RE: NR-0469-S-113-S

# selectSeed labels with UDI implementation

# Explanation of Symbols on Product Labels

## Sample of label

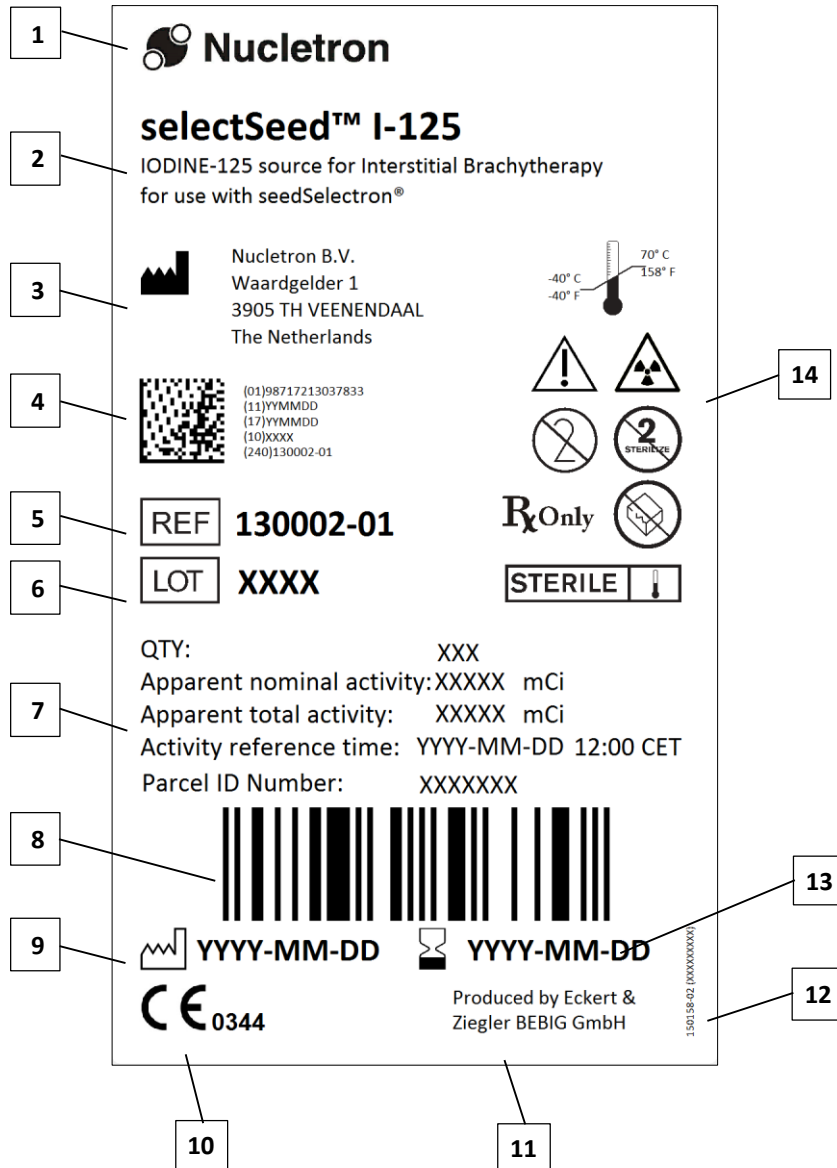
The FDA has classified the selectSeed I-125 as an IIL product (with product code KXK). Therefore, to meet UDI (Unique Device Identifier) compliance, the labelling is required to be modified slightly. To explain the changes, please see attached the new label template specification for the *selectSeed Shipment/Sales Box label (150158-02)*. Additionally, attached is the *Explanation of Symbols on Product Labels (777.00487 MAN)* that will be included in the selectSeed package to explain to the user the meaning of the UDI symbols.

Based on these changes, please amend the Sealed Source and Device Registry, NR-0469-S-113-S, with the updated labels as per the attached document *selectSeed labels with UDI implementation*.

ID	Field	Variable	Value or instructions	Font or Size
1	Company Logo	N	Nucletron. Use delivered file.	30 x 12 mm
2	Product Name	N	<b>selectSeed™ I-125</b>	Calibri, pt. 16
	Product Details	N	<b>IODINE-125 source for Interstitial Brachytherapy for use with seedSelectron®</b>	Calibri, pt. 9
3	Manufacturer Name and Address	N	<b>Nucletron B.V., Waardgelder 1, 3905 TH Veenendaal, The Netherlands</b> Symbol: ISO 15223-ISO 7000-3082	Calibri, pt. 8

4	DataMatrix	Y	Type: GS1 DataMatrix Symbol height (min): 0,255mm Symbol height (target): 0,38mm Symbol height (max): 0,495mm Quiet zone >= symbol height	
	DataMatrix content	N	AI 01 = GTIN ( <b>98717213037833</b> )	Calibri, pt. 6
		Y	AI 11 = Manufacturing date in YYMMDD	Calibri, pt. 6
		Y	AI 17 = Use by date in YYMMDD (Manufacturing date plus 4 weeks = 28 days)	Calibri, pt. 6
		Y	AI 10 = Lot number	Calibri, pt. 6
		N	AI 240 = Part number including major revision	Calibri, pt. 6
5	REF	N	Reference number: <b>130002-01</b> (Technical part number including major revision) Symbol: ISO 15223-ISO 7000-2493	Calibri, pt. 14
6	LOT	Y	Lot number. Symbol: ISO 15223-ISO 7000-2492	Calibri, pt. 14
7	QTY (Quantity)	Y	Quantity specified by customer order. Format: 3 digits.	Calibri, pt. 10
	Apparent nominal activity	Y	Nominal activity per seed, in mCi, at the reference time. Format: 5 digits.	Calibri, pt. 10
	Apparent total activity	Y	Cumulative nominal activity for all seeds, in mCi, at the reference time. Format: 5 digits.	Calibri, pt. 10

Activity reference time	Y	Date of the last Monday at 12:00 CET preceding the manufacturer date in YYYY-MM-DD	Calibri, pt. 10
	Parcel ID number	Y	Parcel ID number determined during manufacturing. Format: 7 digits	Calibri, pt. 10
8	Barcode	Y	Parcel ID and format specified by supplier.	
9	Manufacturing date	Y	Manufacturing date (date of sterilization) in format: YYYY-MM-DD. Symbol: ISO 15223-ISO 7000-2497	Calibri, pt. 12
10	CE mark	N	A minimum height of 5 mm is required to ensure that it is legible. Add also <b>0344</b> .	
11	Supplier	N	<b>Produced by Eckert &amp; Ziegler BEBIG GmbH.</b>	Calibri, pt. 8
12	Label template number	N	Label template number of manufacturer and if necessary template number of supplier	Calibri, pt. 4
13	Used by date	Y	Manufacturing date plus 4 weeks = 28 days in YYYY-MM-DD. Symbol: ISO 15223-ISO 7000-2607	Calibri, pt. 12
14	'Radiation' symbol	N	Symbol: ISO 7010-W003	Width: 9 mm
